## **MEDICAL OFFICE BUILDING**

### **TEXAS ACCESSIBILITY STANDARDS INSPECTION**

TDLR Project No. EABPRJ A

### **INSPECTION COMPLETED – VIOLATIONS PENDING**

Fig 10

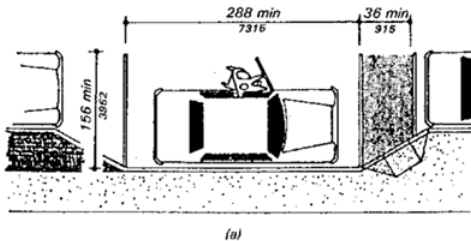
**Cross slope exceeds 2% at passenger loading zone and there is no accessible aisle.**

Passenger Loading Zone  
Slope 2.6%

No Access Aisle  
from Passenger Loading

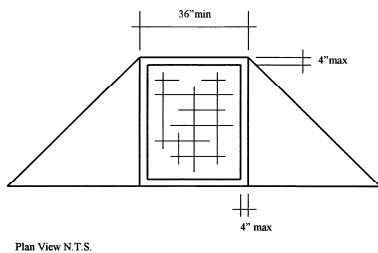
**Light reflective value and surface texture do not have sufficient surface contrast at curb ramps:**

Curb Ramp at west sidewalk

Curb ramp at east sidewalk.

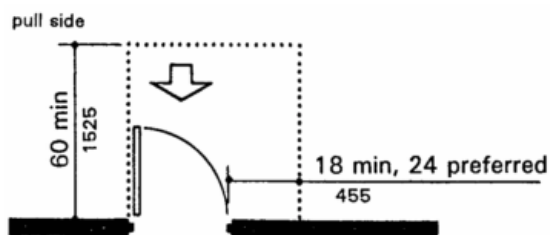
**Cross slope on curb ramps exceeds 2% at the following locations:**

West accessible ramp slope  
slope 2.6%

East accessible ramp  
slope 2.5%

East accessible ramp  
slope 2.6%

**Fig. A8**  
**Control Reach Limitations**

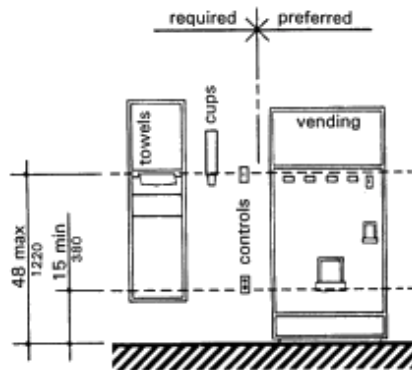
**Paper towel dispenser exceeds the maximum height of the finish floor:**

**Paper towel dispenser in men's  
off lobby is over 48" above the floor**
